**RECALL
BULLETIN:
191125REV**

**YEAR(S)
AFFECTED:
2016-2020**

Inspection /
Correction
of Generator
Exhaust Pipe
Routing

ISSUE DATE:
January 2020

Figure 1

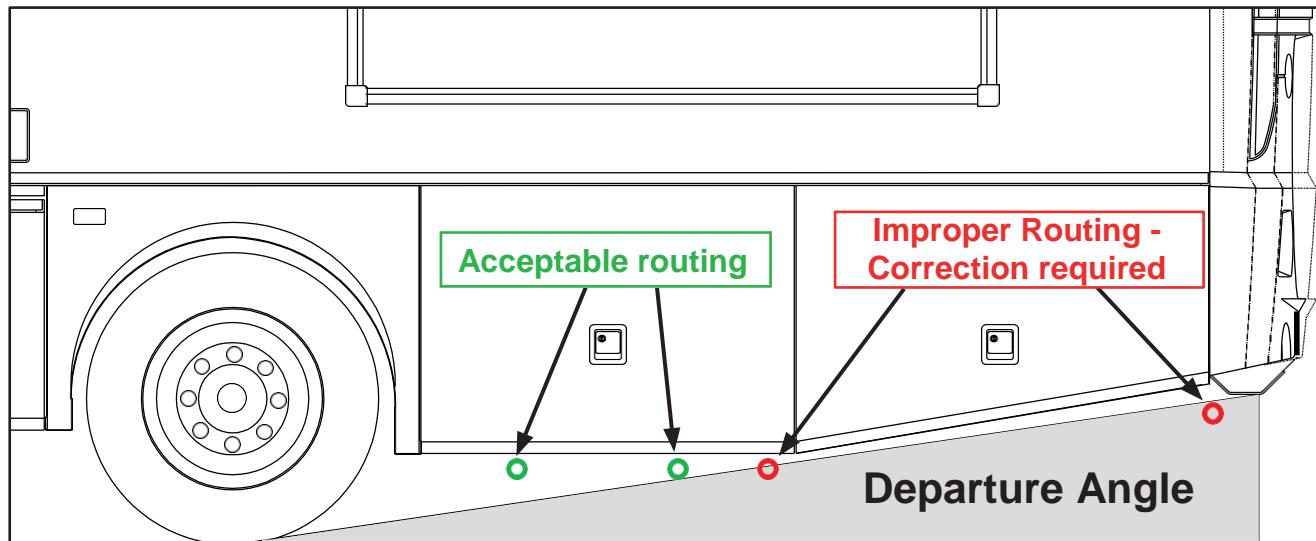
- Using a heavy gauge string (e.g. chalk line or mason line), wedge or hook one end under the point where the rear tire contacts the ground.
- Have an assistant pull the string tight and hold it against the lowest point on the trailer hitch skid plate; see Figure 1.

This will create a wedge with the ground surface as shown in Figure 2. The gray shaded area is the departure angle.

- While at eye level, observe whether the generator pipe is above the departure angle (above the string) or in the departure angle (below the string). Refer to Figure 2.

Figure 3

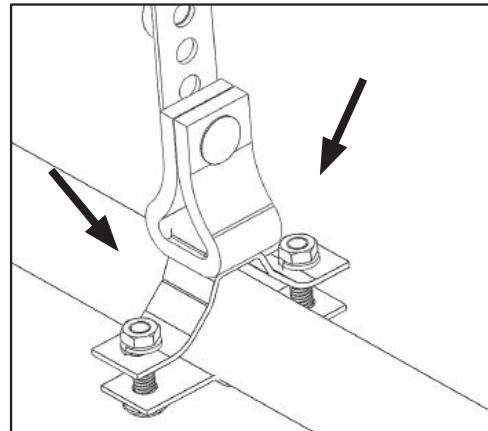
- Referring to Figure 3, find and remove the generator exhaust hanger bracket located near the sidewall. After the exhaust hanger is loose from the pipe, locate the upper fastener securing the hanger to the coach. Remove it and set the exhaust hanger aside for possible reinstallation.
- With the exhaust hanger removed, locate and remove the fasteners holding the exhaust guard to the motorhome. See Figure 4. Set the exhaust guard aside for possible reinstallation.

Figure 6

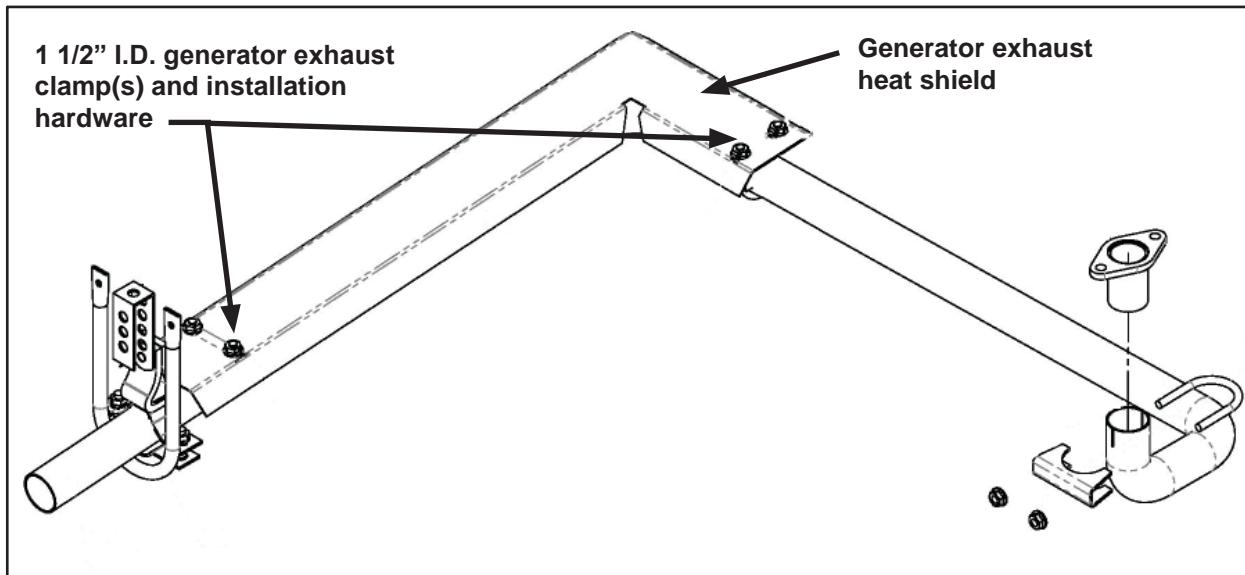
11. Begin reinstallation by installing the new exhaust heat shield onto the new generator exhaust pipe using (two) 1 1/2" I.D. exhaust clamps in the location shown in Figure 6.

Figure 9

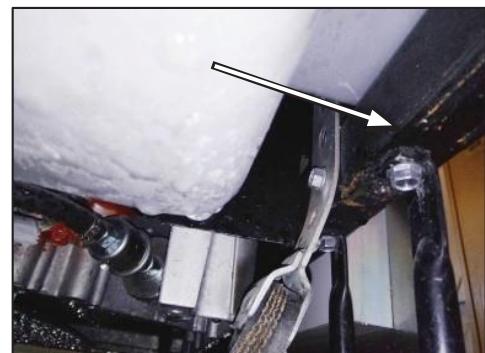
- With the luggage door open, attach the generator exhaust hanger removed in Step 6 to the generator exhaust pipe using the original hardware. Once attached to the generator exhaust pipe, use a 1/4-20 X 1" HWH self-drilling screw to secure the exhaust hanger to the square steel tube located behind the luggage door fascia. Verify the pipe is mounted in a location that will allow the luggage door to close without contacting the exhaust pipe. Refer to Figure 9.

Figure 14

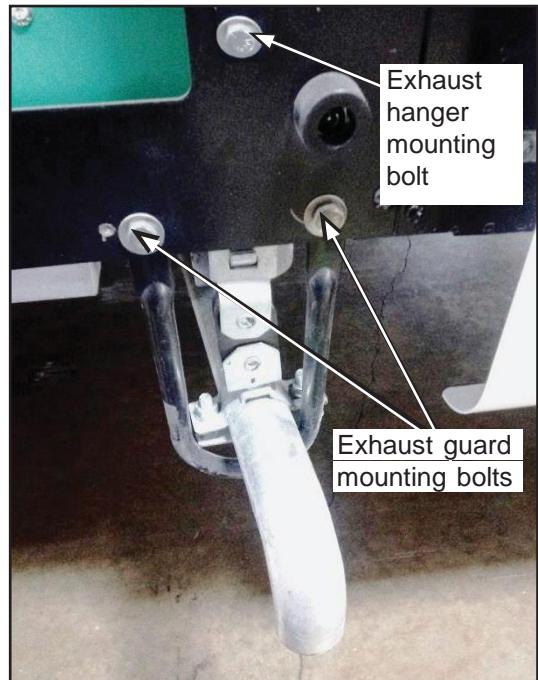
18. With the luggage door open, use the generator exhaust hanger removed in Step 6 as a template to locate and drill a 5/16" hole above the generator exhaust pipe in the metal luggage door fascia as shown in Figure 14.
19. Move the generator exhaust hanger behind the metal luggage door fascia and secure it in place with a 1/4 - 20 x 1 bolt and lock nut, using 1/4" flat washers on the inner and outer surfaces of the union.
20. Finish installing the generator exhaust hanger by installing the bottom portion of the hanger around the generator exhaust pipe.
21. Close and reopen the luggage door to verify that there are no interferences; adjust as needed.
